Parking Assessment Site Redevelopment – Proposed Housing 553-559 Islington Street Portsmouth, NH

#### RE: Request for Site Plan Approval at 553 – 559 Islington Street, Tax Map 157 / Lot 3

# PROPOSED REDEVELOPMENT 553-559 ISLINGTON STREET PORTSMOUTH, NEW HAMPSHIRE PERMIT PLANS

3019.01

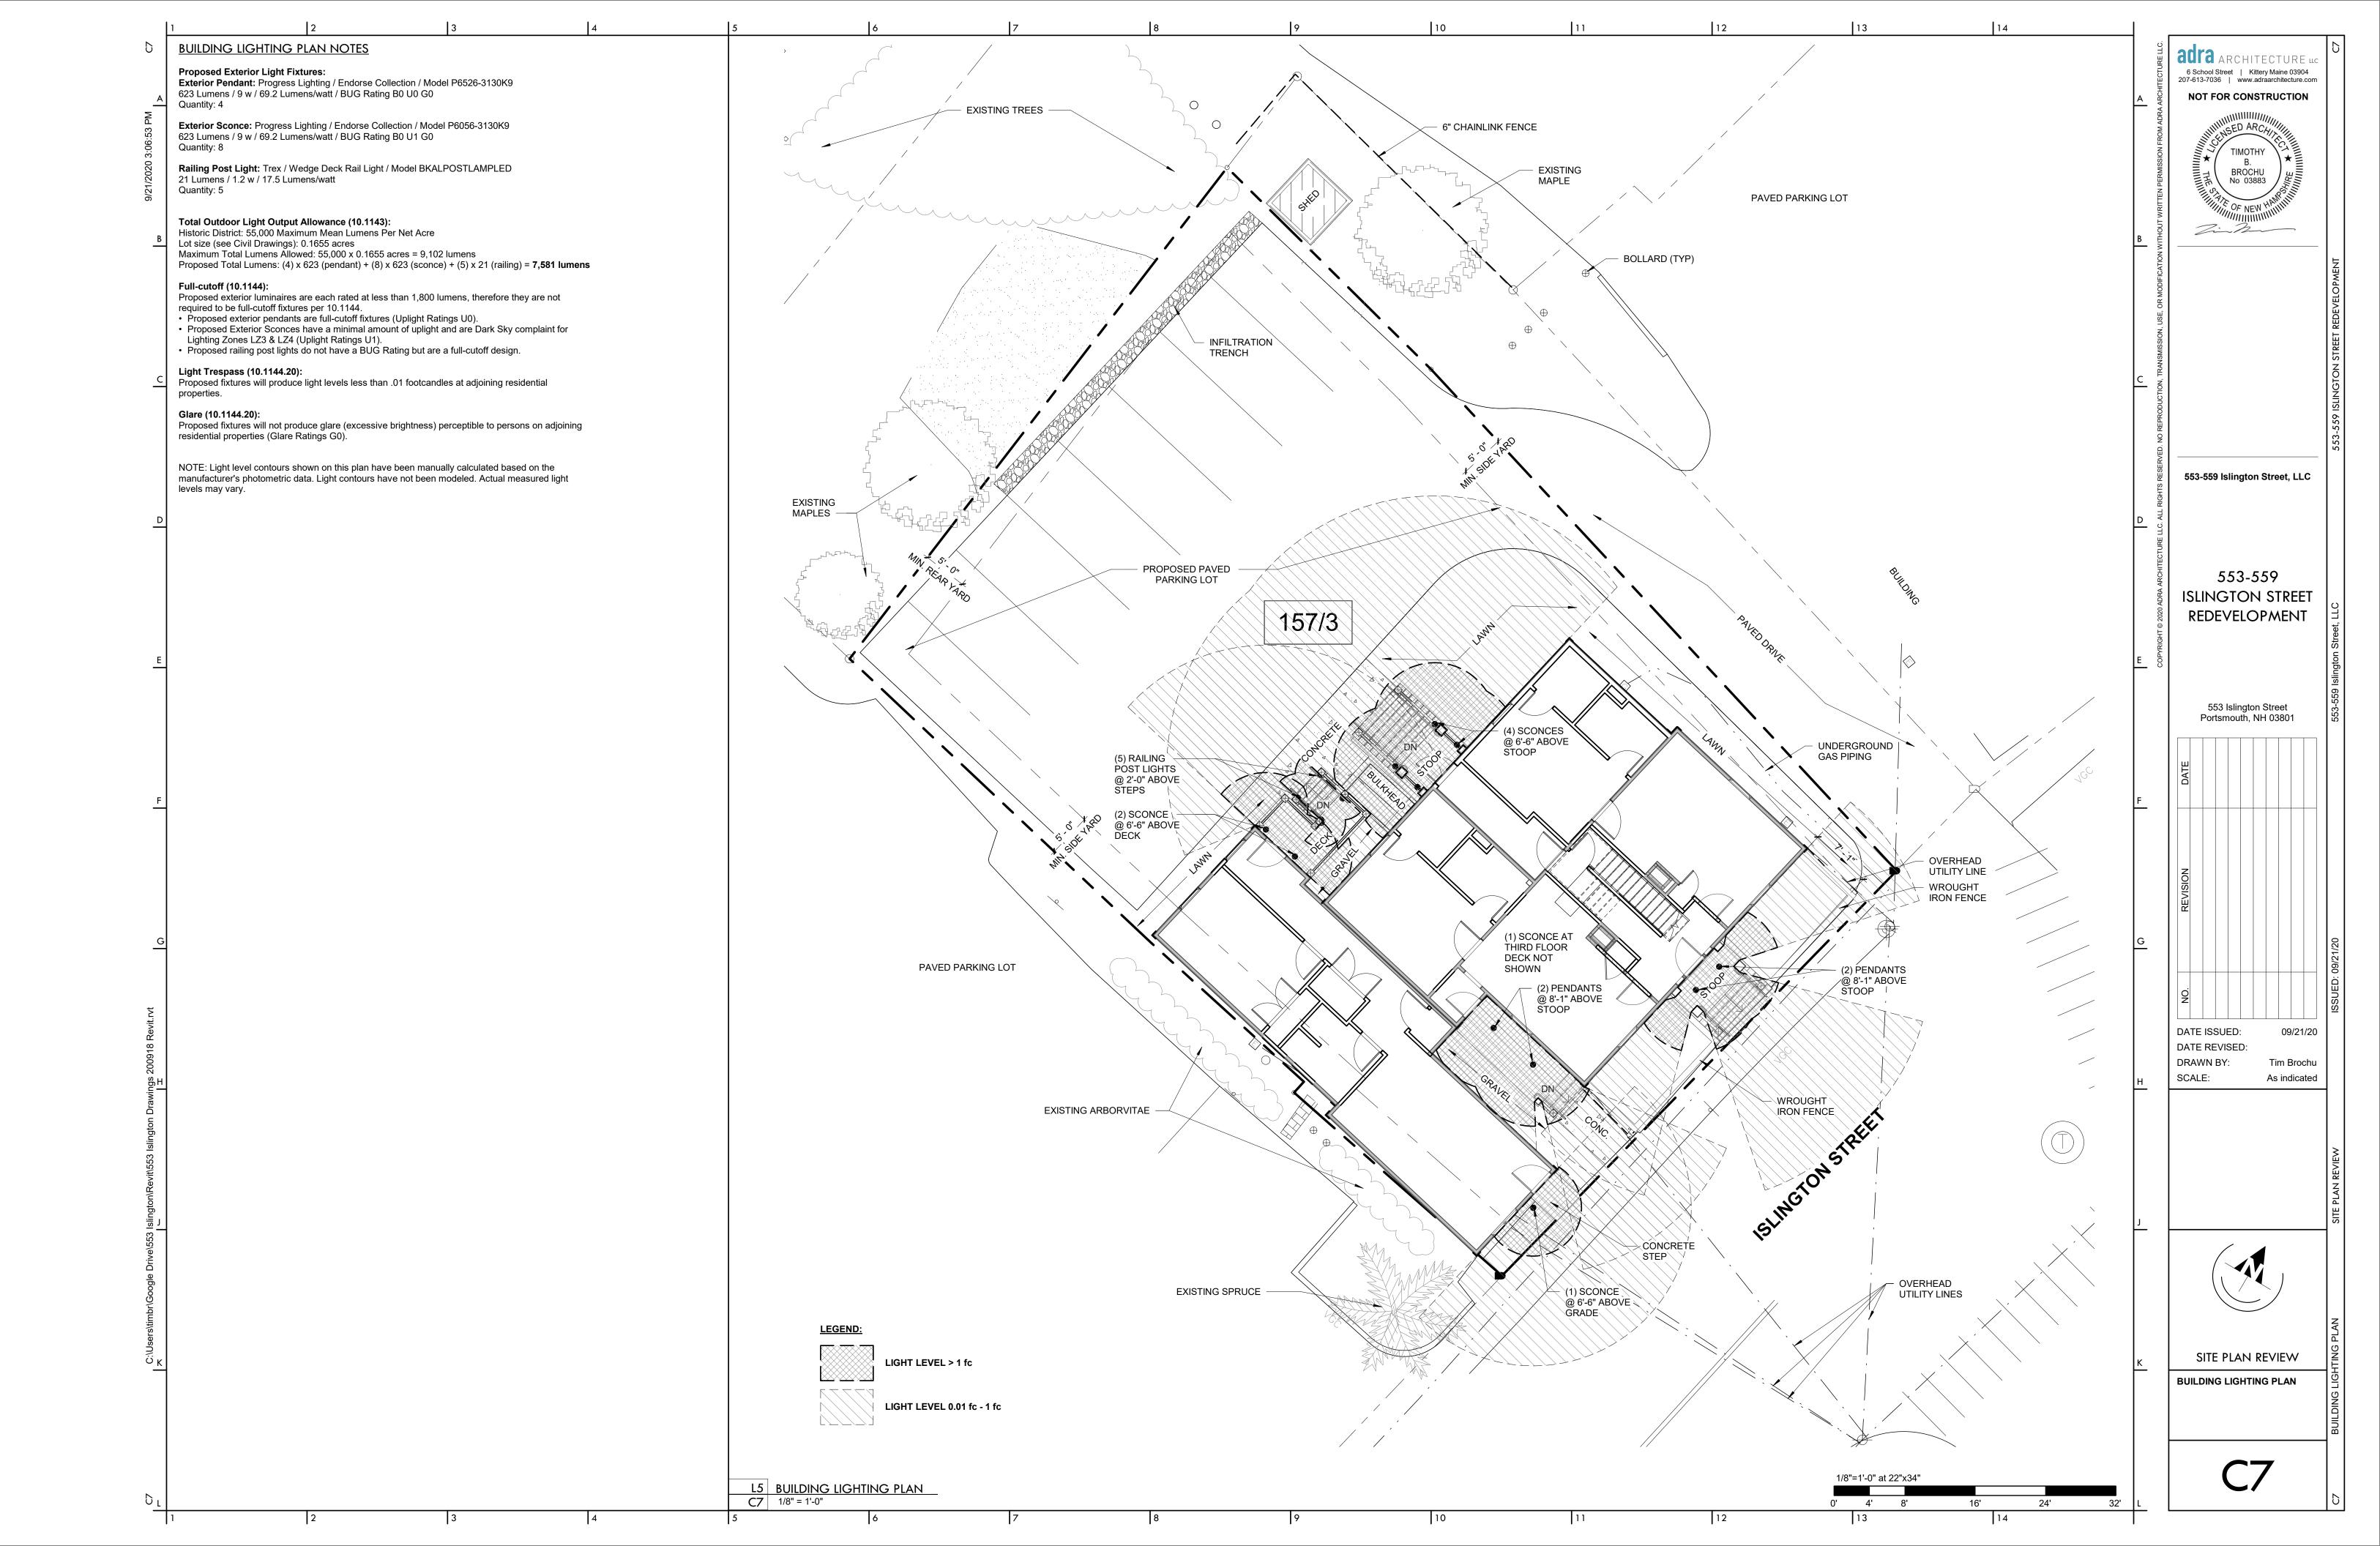
- 1. The sewer shown on this plan 'by the City' will not happen prior to this project. Do not flow fill the existing sewer. It is ok to show a future sewer line and 'coordinate with the City' in the future. Right of access for the future installation of this line by the City should be acquired during this process. If needed, sewer should be replaced out to the edge of parking from the building now before new stairs are constructed. New sewer lateral will connect at that spot in the future. Notes to clarify this are on Sheet C4 as Note 8. The plan notes the right of access shall be granted to the city, also see Note 13 on Sheet C3. The plan notes construction of the lateral for the *future* connection.

- 2. A temporary construction easement shall be provided to the City for future installation of sewer line and the plan shall be updated to note the required easement. The plan notes the right of access shall be granted to the city, also see Note 13 on Sheet C3.

13) CITY TO BE GRANTED RIGHT OF ACCESS AND TEMPORARY CONSTRUCTION EASEMENT TO CONNECT FUTURE SEWER SERVICE ACROSS LOT AND EASEMENT AREA.
